IDA PAPER P-3016

INDEPENDENT REVIEW OF THE DEVELOPMENT RISKS ASSOCIATED WITH THE COMANCHE ARMED RECONNAISSANCE HELICOPTER

August 1994

Prepared for
Director, Tactical Warfare Programs

EXISTING CONTRACTED DEVELOPMENT PROGRAM

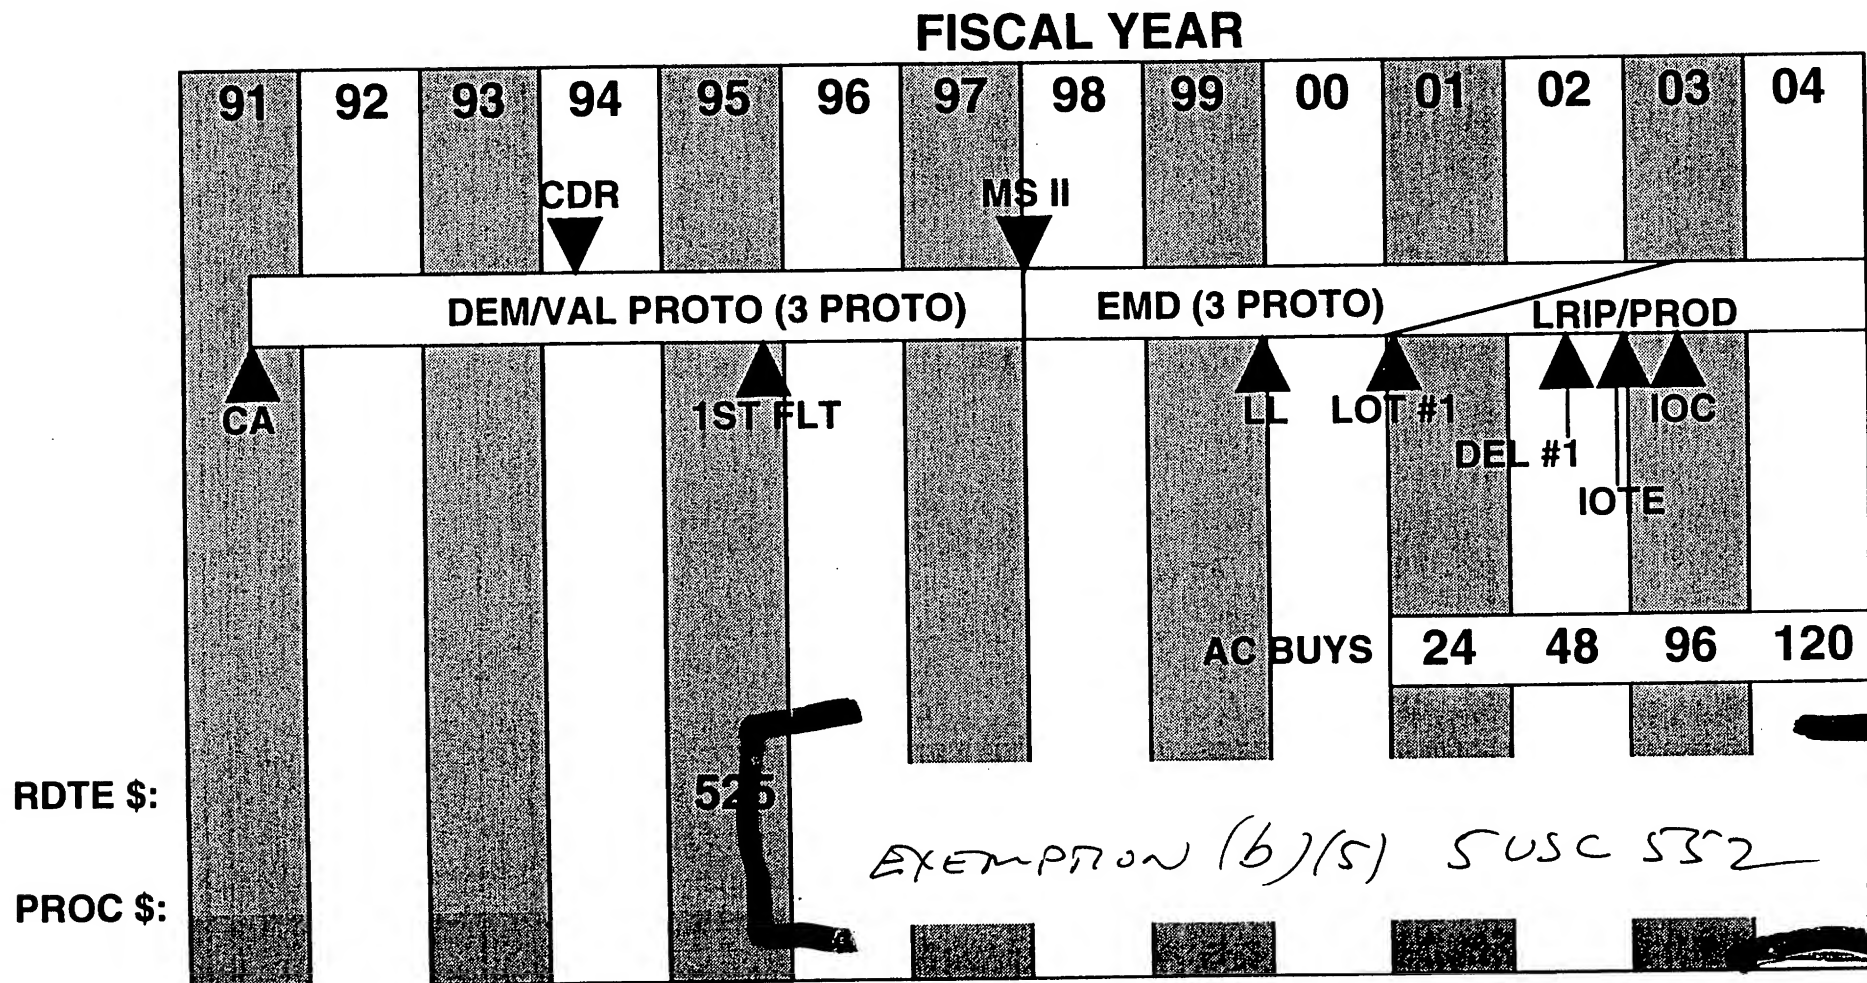
This chart shows the schedule and funding profile for the existing, contracted COMANCHE development program. Actually, only the DEM/VAL phase is currently under contract. If this development plan were continued, the Army's COMANCHE Program Office and the Boeing-Sikorsky Joint Program would soon need to begin negotiating a contract for the EMD phase of development.

As indicated on the schedule, this program features three prototype aircraft built and tested during the DEM/VAL phase, with first flight of the first COMANCHE prototype scheduled for November 1995. Three additional prototypes would be built and tested during the EMD phase. At the conclusion of DEM/VAL and prior to the award of the EMD contract, a Milestone II review would be held for the program. Long-lead production would begin at the end of FY 1999 and the first 24 production aircraft would be funded in FY 2001. Plans call for production to ramp up to 48 in FY 2002, to 96 in FY 2003, and to the full production rate of 120 per year by FY 2004. The first production aircraft would be delivered to the Army in mid FY 2002. The Initial Operational Test and Evaluation (IOTE) would be held early in FY 2003. Initial Operating Capability would be achieved by mid FY 2003.

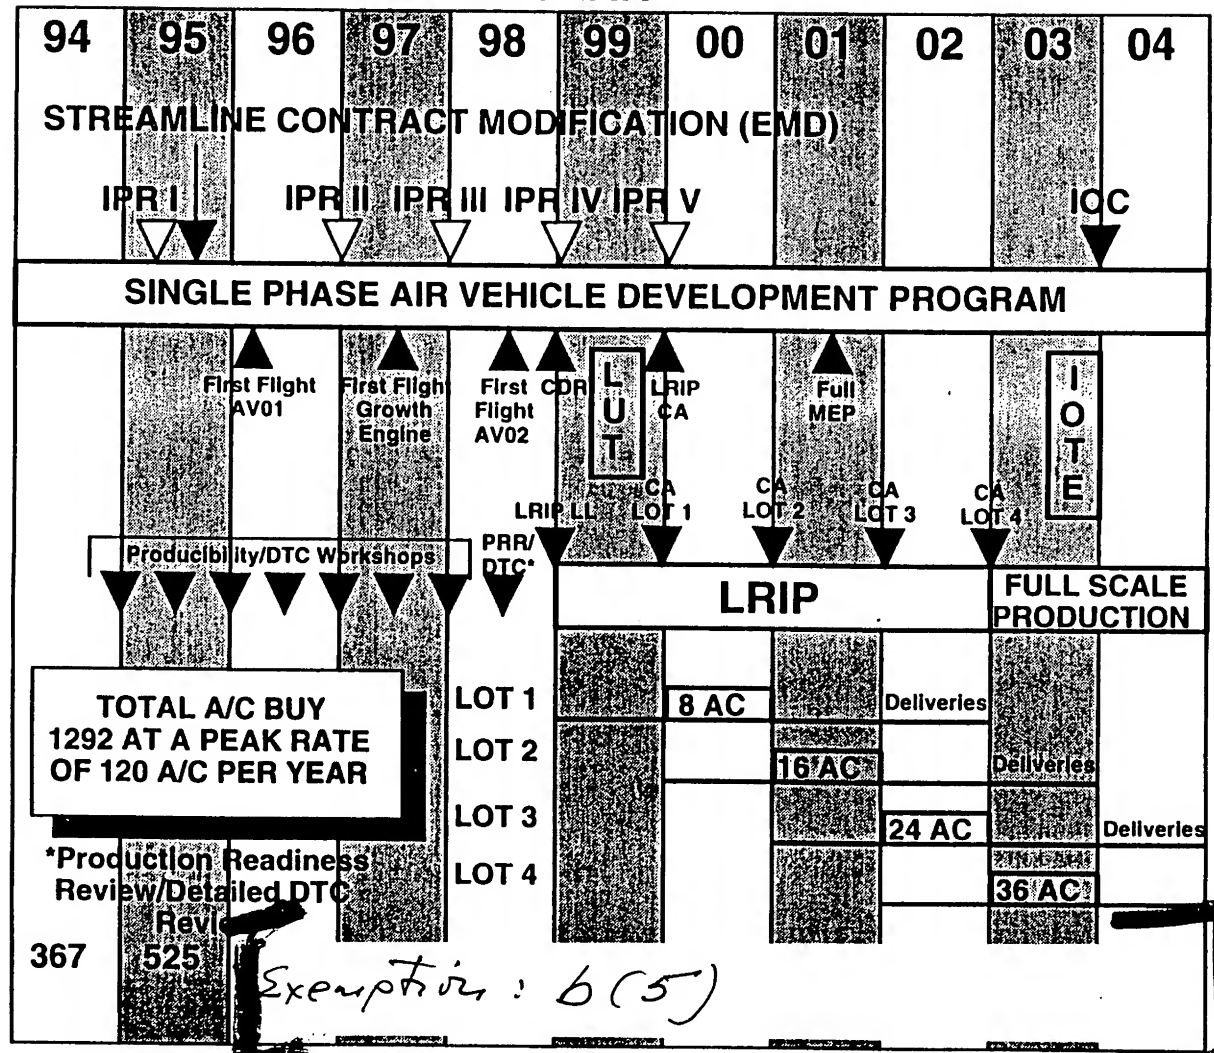
The schedule for the "streamlined" development program proposed by the Army is shown on this chart. Under this plan, in May 1995 the Army would modify the existing COMANCHE development contract to incorporate the activities normally conducted during EMD into a new single-phase development program. The first flight of the first of two DEM/VAL prototypes would occur in early FY 1996, several months later than was proposed under the existing development contract. The first flight of the second DEM/VAL prototype would not occur until late FY 1998, nearly 2 1/2 years after the first flight of the first prototype. The next three prototypes would be taken from the first lot of eight Low-Rate Initial Production (LRIP) aircraft. These prototypes would be delivered to the Army during FY 2002.

In comparison to the Army's previous plan for COMANCHE development, the "streamlined" plan initiates production one year earlier, but at a significantly slower rate. In the first year (FY 2000), only 8 aircraft would be built; in the second, 16 aircraft; in the third, 24 aircraft; and in the fourth (FY 2003), 36 aircraft.

OSD oversight for this program would be accomplished through a series of In-Process Reviews (IPRs), the first of which would occur early in FY 1995 prior to the award of the modified development contract. Beginning at the end of FY 1996, in-process reviews would

be scheduled annually to enable OSD to track program development.

Finally, as indicated on the chart, the funding profile for the proposed "streamlined" program is the same as is currently planned for the existing program.
